STAFF RECOMMENDATION
1900 5th Avenue North
April 19, 2017

Application: New construction—addition
District: Salemtown Neighborhood Conservation Zoning Overlay
Council District: 19
Map and Parcel Number: 08108009800
Applicant: Cheyenne Smith
Project Lead: Melissa Baldock, melissa.baldock@nashville.gov

Description of Project: Application is to construct a rear addition that is taller than the historic house.

Figure 2 (top left) shows the window opening that will be removed. Figure 3 (bottom left) shows the window opening that will be altered in size. Figure 4 (right) is the 1951 Sanborn Map that shows that the area in question was formerly a covered porch.

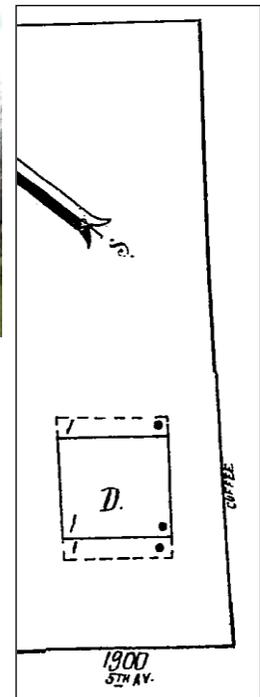
Partial Demolition: The project involves altering two window openings on the existing house. On the left side, the applicant will be removing a window opening at the back (Figure 2). On the right elevation, the applicant will be altering the size of a window opening at the rear (Figure 3). Both window openings are located at the back of the house, under an historic extension that was formerly an enclosed porch, according to the 1951 Sanborn Map (Figure 3). Therefore, these sections of the side walls of the house are likely not original, and the window openings are also likely not original. Because of their location, staff finds that the

removal and alteration of the window openings on the left and right façades meets the design guidelines. Staff finds that this partial demolition meets Section V.B.2 for appropriate demolition and does not meet section V.B.1 for inappropriate demolition.

01 SITE PLAN Scale: 1/16"=1'-0"

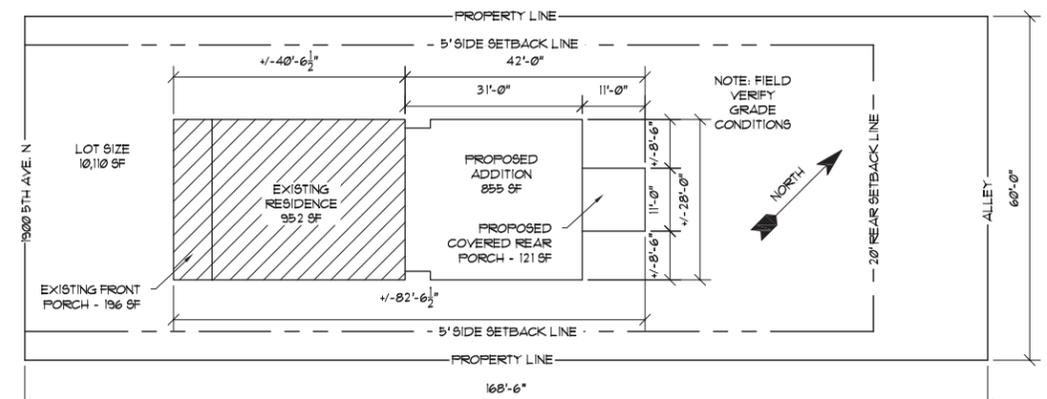
Setback & Rhythm of Spacing: The proposed addition meets all base zoning setbacks. It will be fourteen feet (14') from the Coffee Street property line, and it will be eighteen feet (18') from the left side property line. It will be approximately sixty feet (60') from the rear property line. Since the addition is no wider than the historic house, it will not affect the rhythm of spacing along 5th Avenue North. Staff finds that the addition's setbacks meet Section III.C. of the design guidelines.

01 SITE AND DEMO PLAN EXTERIOR ELEVATIONS

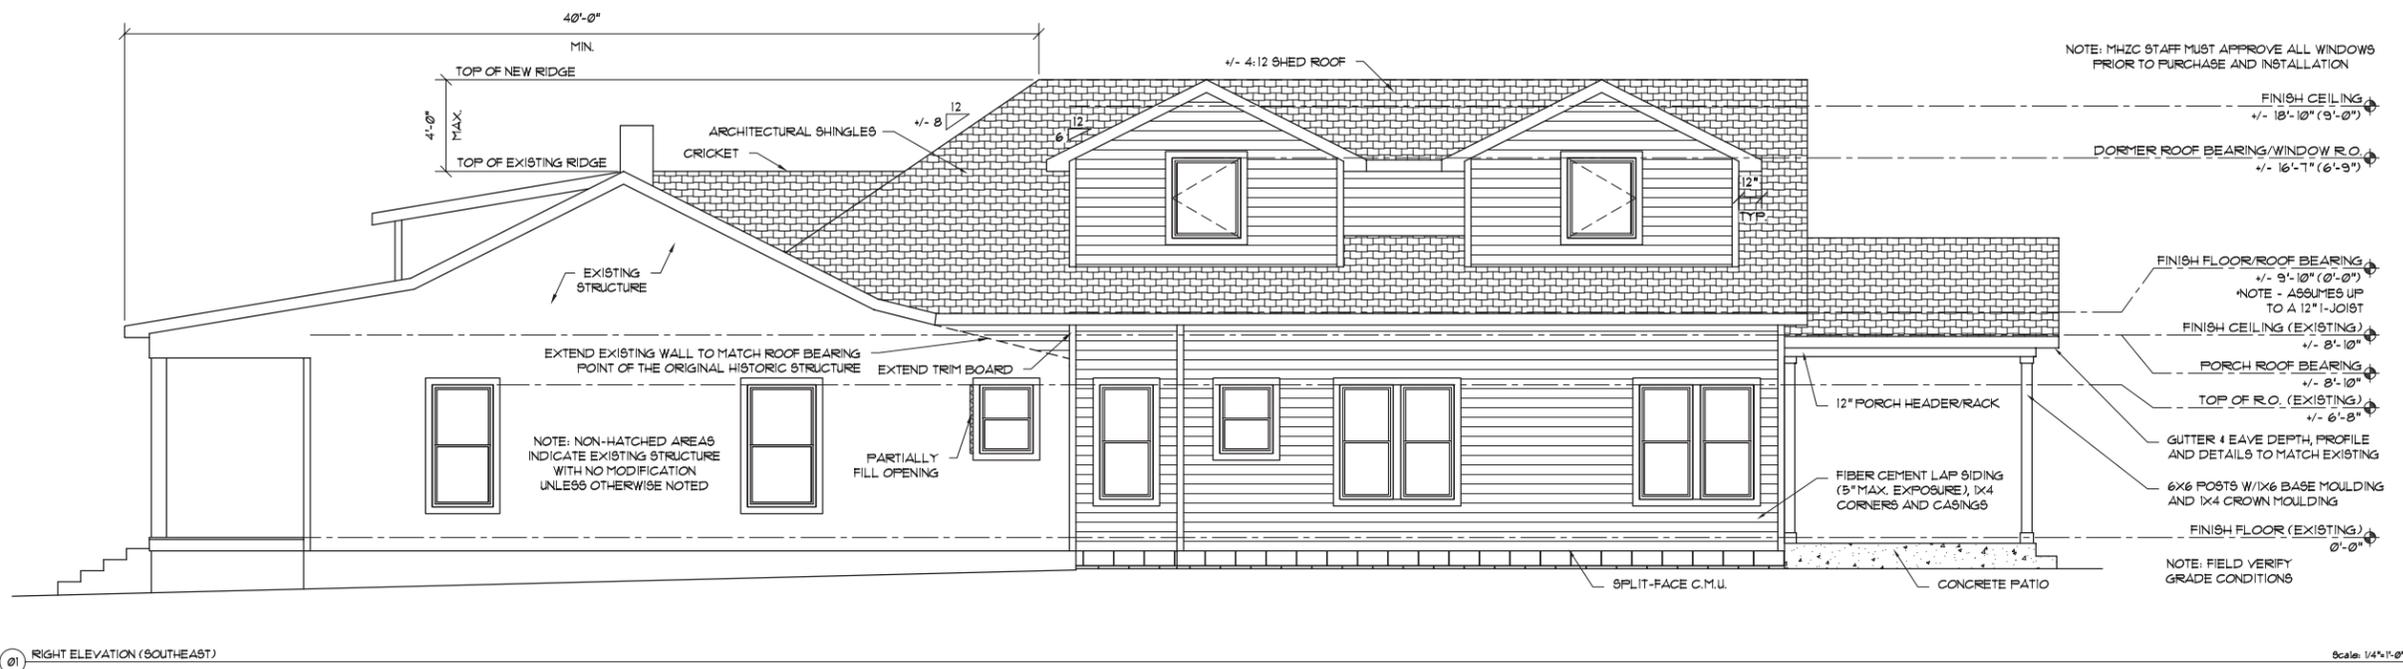
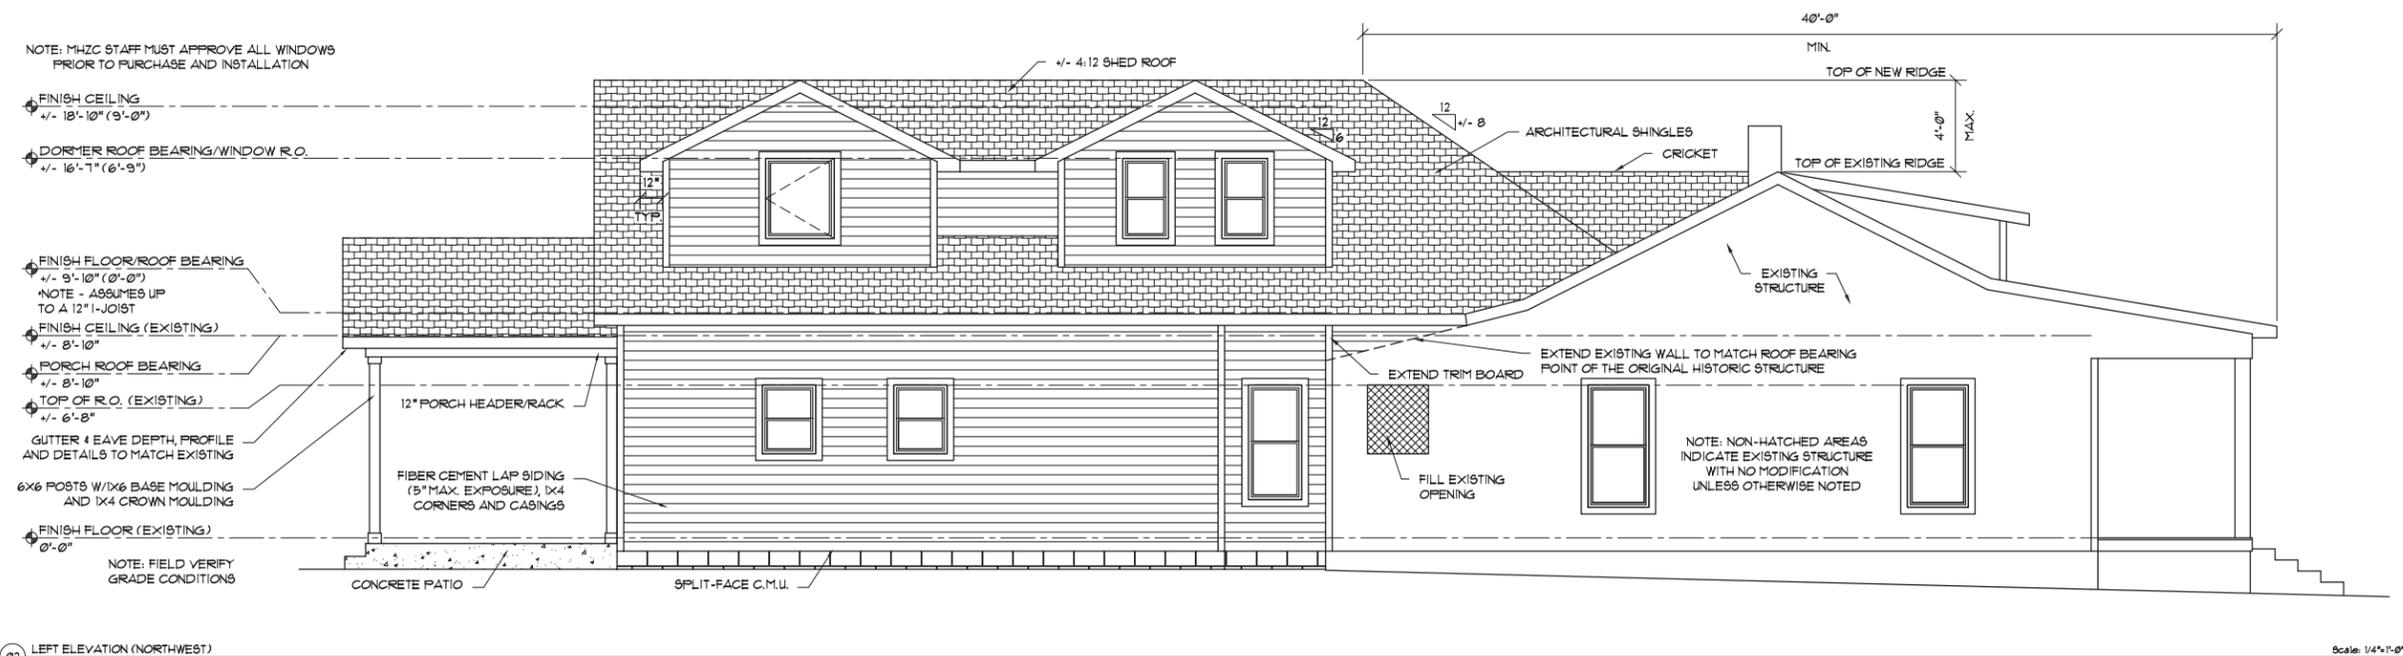
Height & Scale: The proposed addition will add approximately nine hundred and seventy-six square feet (976 sq. ft.) of footprint to the historic house, which has a footprint of approximately one thousand, one hundred and forty-eight square feet (1,148 sq. ft.). The proposed addition is set in from the back corners of the historic house eighteen inches (18") on the ground floor, and two feet (2') on the second story. After a depth of four feet, five inches (4'5"), on the ground floor, the addition steps back out to match the width of the historic house. The entire second story is inset two feet (2') from the historic house's sidewalls.

The addition ties into the historic house a few inches below the ridge. After a depth of forty feet (40') back from the front, the addition increases in height to be four feet (4') taller than the historic house. This increased height allows for a one-and-a-half story form, with usable second story space, behind a true, one-story house. Staff finds that the taller addition meets the design guidelines, as it is inset two feet (2') from each the side walls of the historic house, has a clipped and side gable roof forms, and is set back significantly from the front of the house.

Roof form: The historic house has a side gable roof form with a slope of 4.5/12. The proposed roof form is hipped at the front with an 8/12 slope. The side elevations both include connected dormers (also known as a Nantucket dormer). These dormers have 6/12 gables and 4/12 shed roof forms. Staff finds that the proposed roof form meets Section III.E. of the design guidelines.

Proportion and Rhythm of Openings: The changes to the window openings on the historic house are described under "Partial Demolition." The windows on the addition are generally twice as tall as they are wide, thereby meeting the historic proportion of window openings. The window pattern on the right elevation, which faces Coffee Street, is more traditional than the window pattern on the left elevation, which will be less visible from the street. There are no large expanses of wall space without a window or door opening. Staff finds that the proposed fenestration pattern meets Section III.G. of the design guidelines.

recommends that the HVAC be located on the rear façade, or on a side façade beyond the midpoint of the house.
